TOWN OF SHALLOTTE

December 19, 2024

RE: Solserra PUD (Master Plan) & Annexation ANX 24-27 Parcel ID # 1980000205, 198JB00115, 198JC001, 198JC002, & 198JC003

Please find the notes below, which were compiled from the recent Technical Review Committee meeting of your project. I will need responses to each comment as well as revised preliminary plans that reflect those comments and updates.

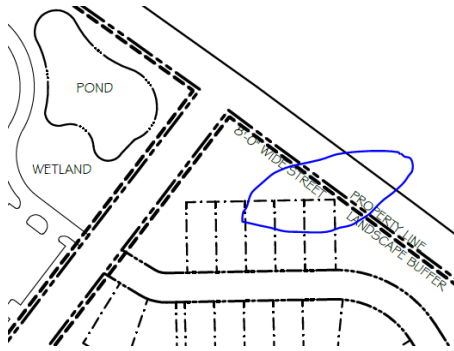
7. Verify sight stopping distance is met without obstruction – particularly here at Tar Landing Rd: **REVISED AND MOVED AWAY FOR PROPERTY LINE AND BUFFER**
